**CPED STAFF REPORT**  
Prepared for the City Planning Commission

CPC Agenda Item #3  
July 28, 2014  
BZZ-6639

*Property Location:* 1201 Plymouth Avenue North  
*Project Name:* Precise Products Corporation Addition  
*Prepared By:* [Mei-Ling Anderson](#), City Planner, (612) 673-5342  
*Applicant:* Darrell Freitag, Precise Products  
*Project Contact:* Todd Ofsthun, TCO Design  
*Request:* To allow an 11,520 square foot addition to an existing building.  
*Required Applications:*

## Preliminary Development Review Report

**SITE PLAN**  
scale 1" = 20.0'

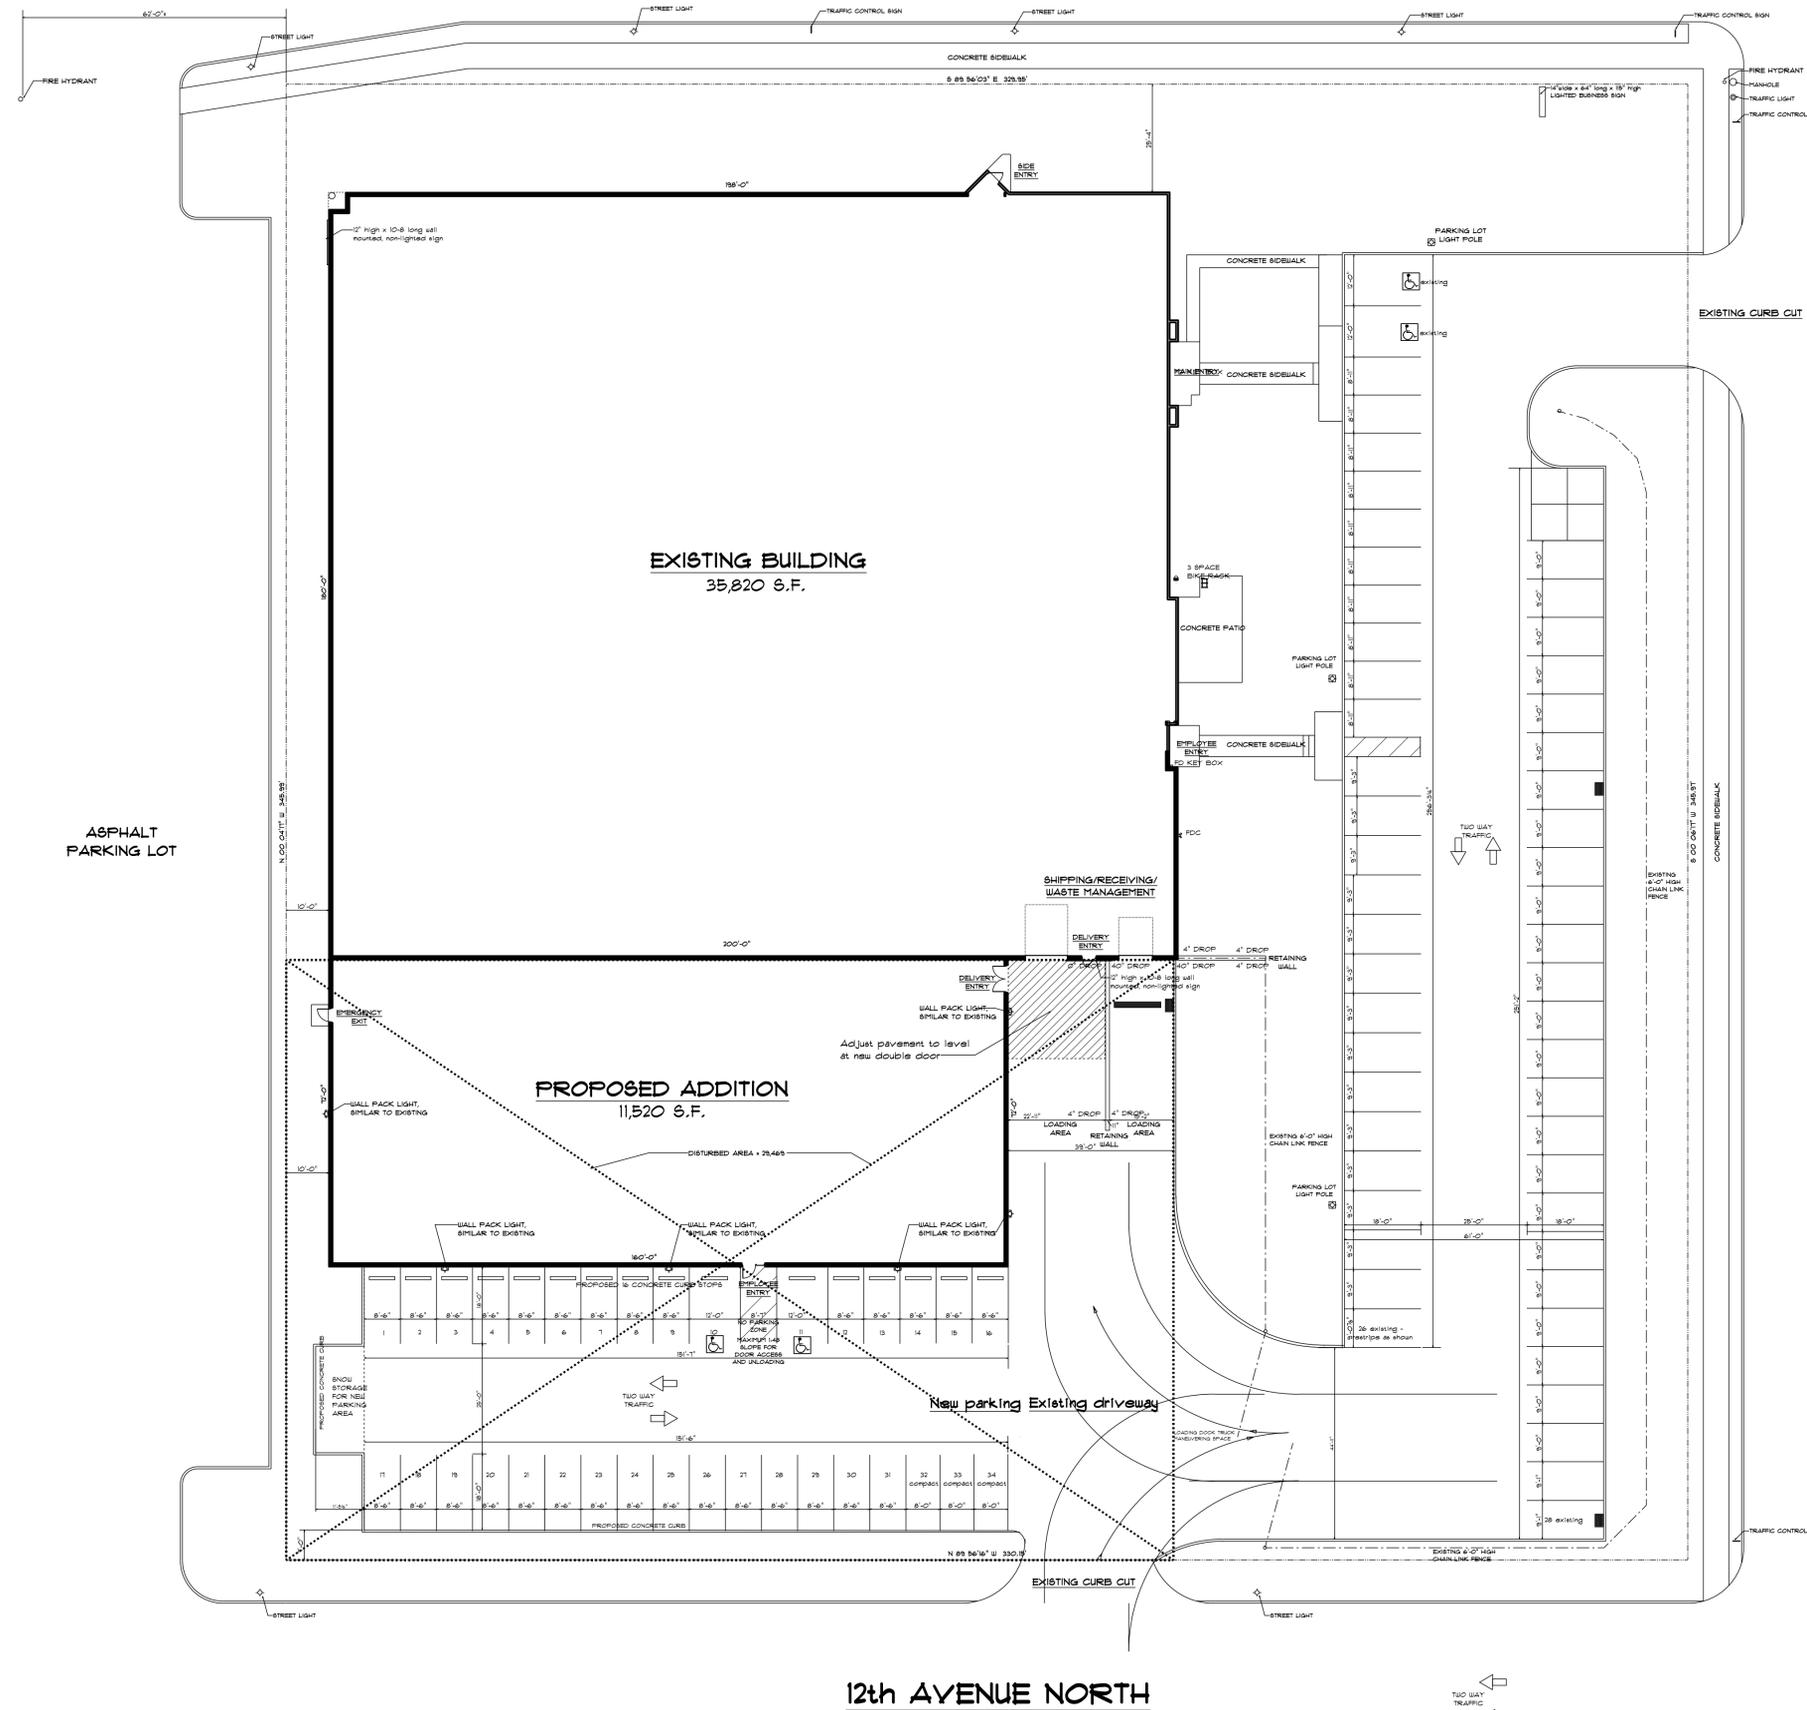
- The new building entrance faces 12<sup>th</sup> Avenue North. There is no existing or proposed public sidewalk along 12<sup>th</sup> Avenue North, and no walkway proposed between the building addition and the on-site parking facilities or to the public street. This item requires alternative compliance.

- The site plan increases the impervious surfaces on the site from 60,336 square feet (52.8%) to 81,819 square feet (71.6% of the site). The applicant is proposing a 26 foot-wide drive

aisle in the new parking area and a 25 foot-wide. The zoning code minimum is 22 feet. In the existing parking area, each of the 54 spaces is larger in width than the zoning code minimum. CPED staff finds that there are additional opportunities to minimize the use of impervious surfaces while maintaining the number of parking spots proposed for the site. This item requires alternative compliance.

- **Pedestrian walkway.** The new building entrance faces 12<sup>th</sup> Avenue North. There is no existing or proposed public sidewalk along 12<sup>th</sup> Avenue North, and no walkway proposed between the building addition and the on-site parking facilities or to the public street. This item requires alternative compliance. Staff finds that it would be practical to require that the applicant provide a four-foot walkway along the south building entrance to connect the south building entrance to the adjacent parking facilities. Staff is recommending that the Commission grant alternative compliance from the requirement that a walkway connect to 12<sup>th</sup> Avenue North because the street does not currently feature a public sidewalk. However, staff encourages the applicant to consider providing a dedicated walkway to the public street.

- **Impervious surfaces.** The site plan increases the impervious surfaces on the site from 60,336 square feet (52.8%) to 81,819 square feet (71.6% of the site). The applicant is proposing a 26 foot-wide drive aisle in the new, south parking area and a 25 foot-wide aisle in the east parking area. The zoning code minimum is 22 feet. In the existing parking area, each of the 54 spaces is larger in width than the zoning code minimum. CPED staff believes there are additional opportunities to minimize the use of impervious surfaces while maintaining the number of parking spots proposed for the site. This item requires alternative compliance. Staff finds that it would be practical to require the applicant to reduce the amount of impervious surfaces in the proposed parking area through a combination of restriping the existing parking area and designing the new parking area in a way that meets the minimum drive aisle and parking space dimension requirements.

5. The applicant shall add features to the doorway facing 12<sup>th</sup> Avenue North to emphasize that it is a principal entrance.
6. The applicant shall provide a four-foot wide pedestrian walkway along the south building wall to connect the principal entrance to new on-site parking facilities.

7. The applicant shall reduce the amount of impervious surfaces in the proposed parking area by adjusting the drive aisle and parking space dimensions and maximizing landscaping.

**LANDSCAPE PLAN**  
 scale 1" = 20.0'

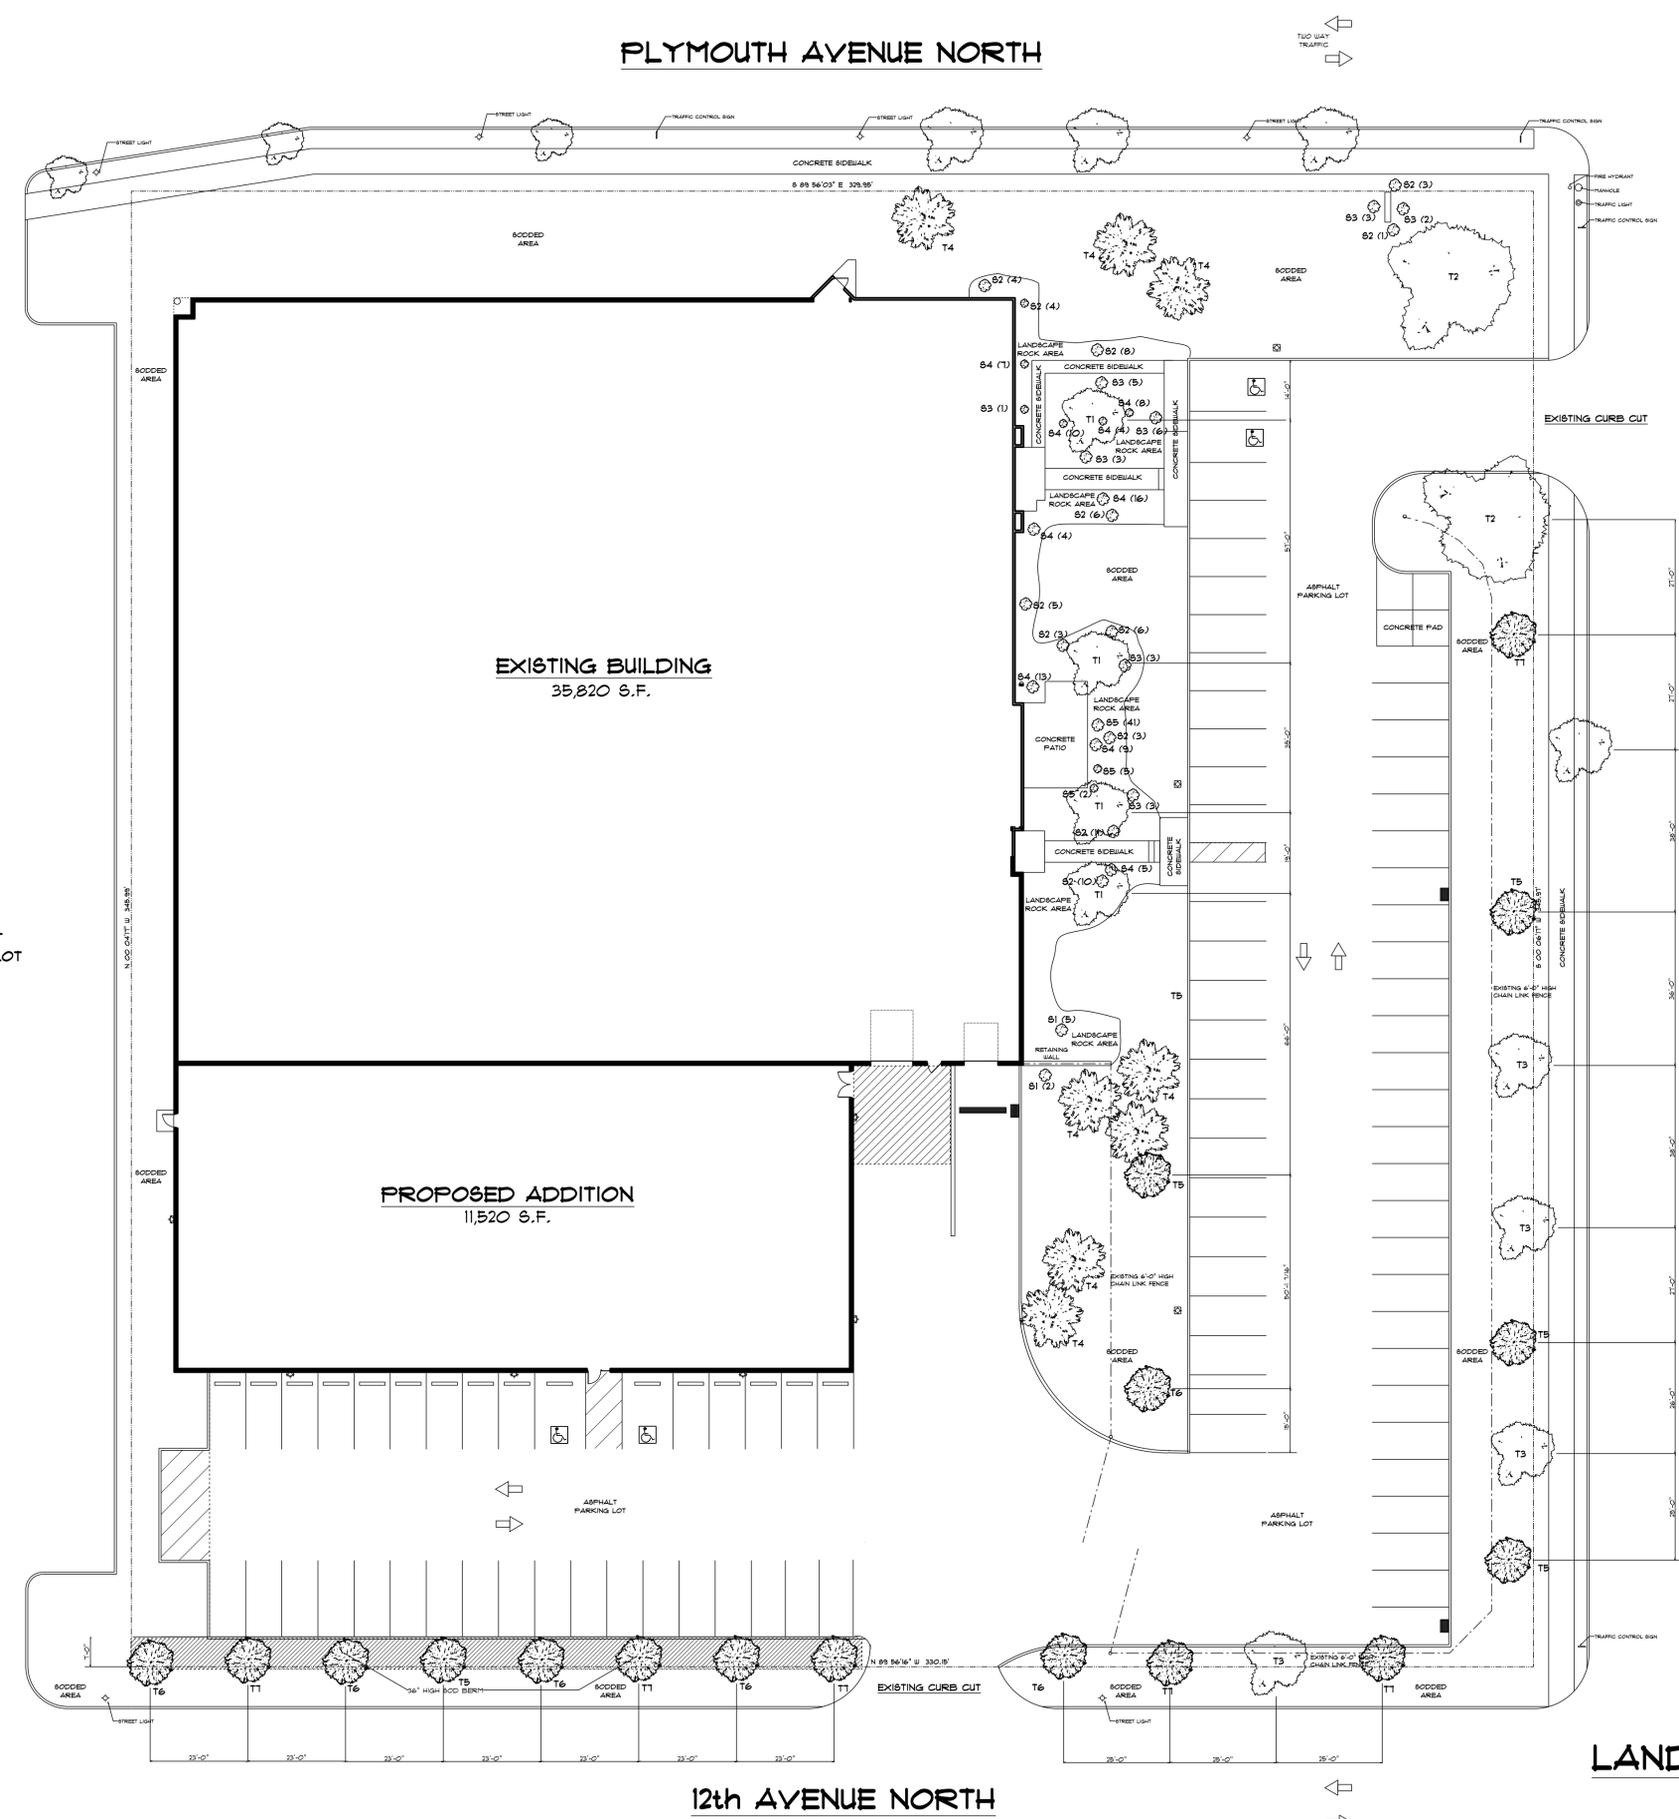
- A three-foot screen that is at least 60 percent opaque is required along all three parking lot frontages. The applicant has indicated that the berms along Plymouth Avenue North and 12<sup>th</sup> Avenue North create a screen of at least three feet in height. The landscaped area along Fremont Avenue North does not meet the minimum height or opacity requirements for the required screen for the parking area. The applicant is requesting alternative compliance.

- Surface parking areas are required to have no less than one tree per each 25 linear feet of parking or loading area frontage. This requirement is met along 12<sup>th</sup> Avenue North but not along Plymouth Avenue North or Fremont Avenue North. The applicant is requesting alternative compliance.

Avenue North and 12<sup>th</sup> Avenue North create a screen of at least three feet in height. The landscaped area along Fremont Avenue North does not meet the minimum height or opacity requirements for the required screen for the parking area. The applicant is requesting alternative compliance. Staff finds that it would be practical to require the applicant to comply with the screening standard along Fremont Avenue North by providing additional shrubs or a dense hedge.

- **Linear tree requirement.** Surface parking areas are required to have no less than one tree per each 25 linear feet of parking or loading area frontage. This requirement is met along 12<sup>th</sup> Avenue North but not along Plymouth Avenue North or Fremont Avenue North. The applicant is requesting alternative compliance. The applicant is proposing to add 17 canopy trees to the site, including four trees along Fremont Avenue North. In order to maintain consistent spacing between the existing trees, the distance between each tree along Fremont, as proposed, would range between 25 and 38 feet. However, there is a boulevard tree between the trees with the largest linear distance. Staff recommends granting alternative compliance in order to maintain the orderliness of the distribution in the new and proposed trees along this side of the property.

- As site plan review regulations apply to the entire site, please indicate the materials of all landscaped and non-landscaped areas.
  - Indicate the species and mature height of all proposed canopy trees and shrubs that will fulfill the landscaping requirement of at least 27 canopy trees and 134 shrubs total. This information is best presented in tabular format in the landscape plan. Clarify the number of existing shrubs on the landscaping plan - currently there are two different numbers provided.

8. The applicant shall provide additional trees, shrubs or a dense hedge along Fremont Avenue North to comply with the parking and loading landscaping and screening requirements.

9. The applicant shall provide additional trees and shrubs in required landscaped yards in order to comply with the minimum landscaping materials for required yards standards per section 530.160 of the zoning code.

**PRECISE PRODUCTS CORP.**  
 MINNEAPOLIS, MINNESOTA  
**COMPOSITE PLAN**  
 PRELIMINARY CONSTRUCTION PLANS

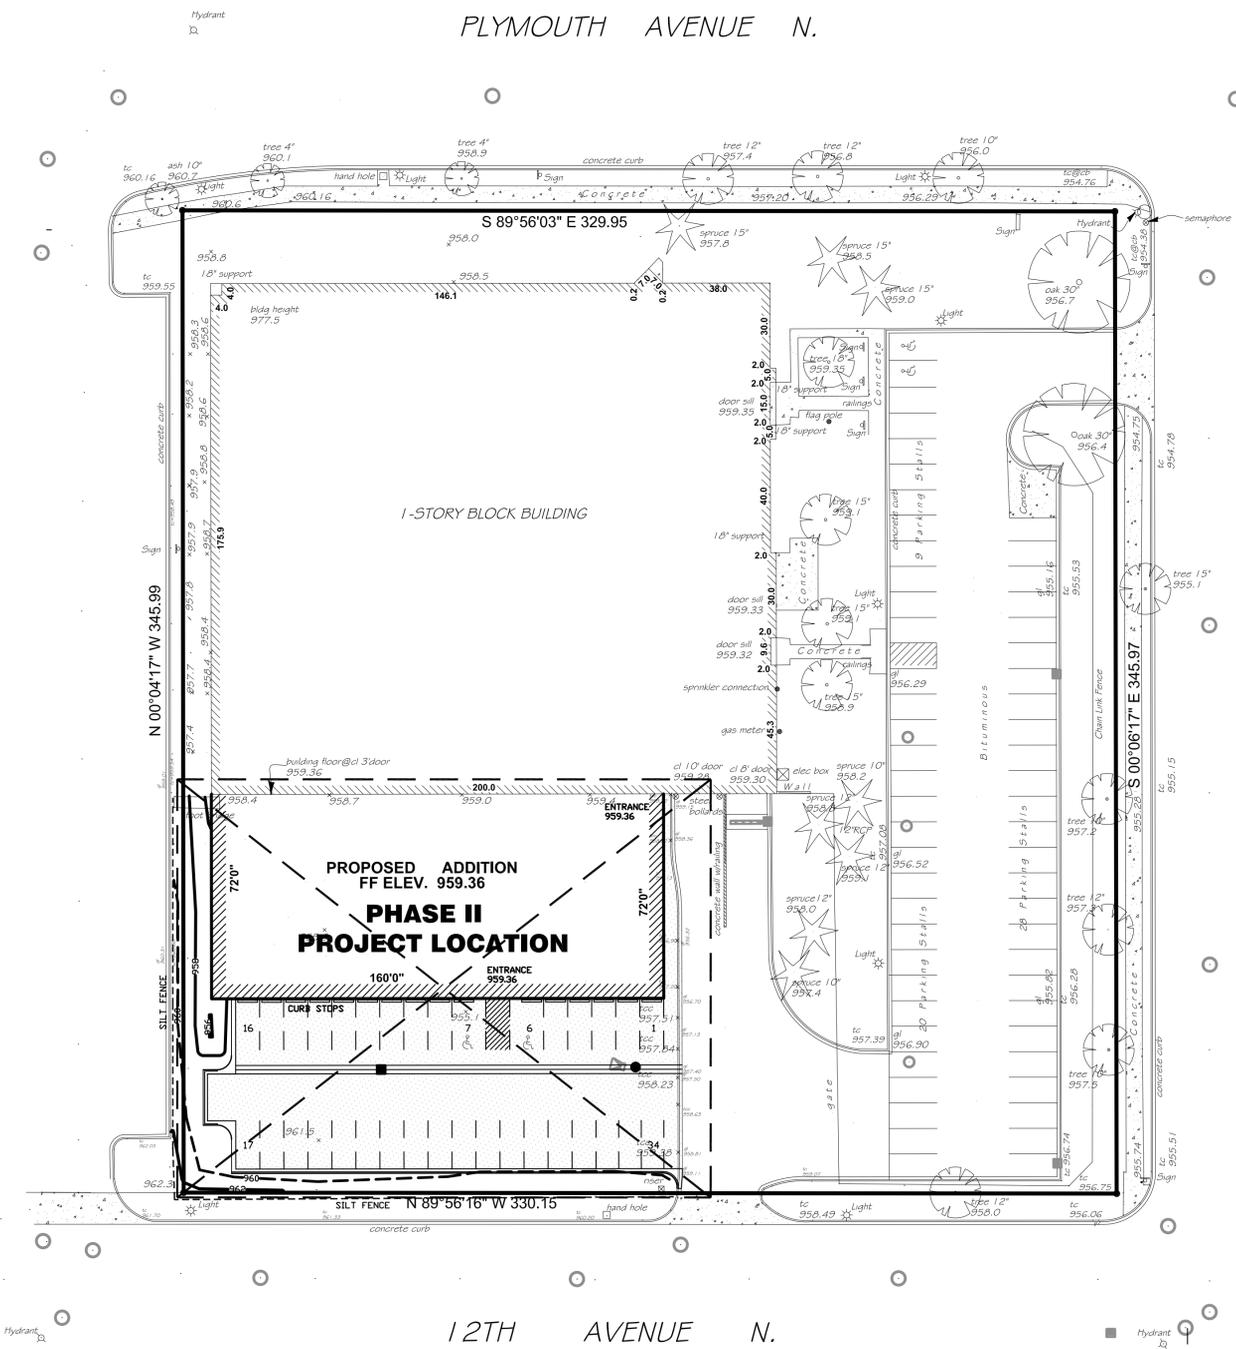
- Utility Connections: All existing storm sewer on the property should be shown on the existing conditions plan. There is storm sewer identified on Sheet C3 as existing but is not shown on the existing conditions survey.
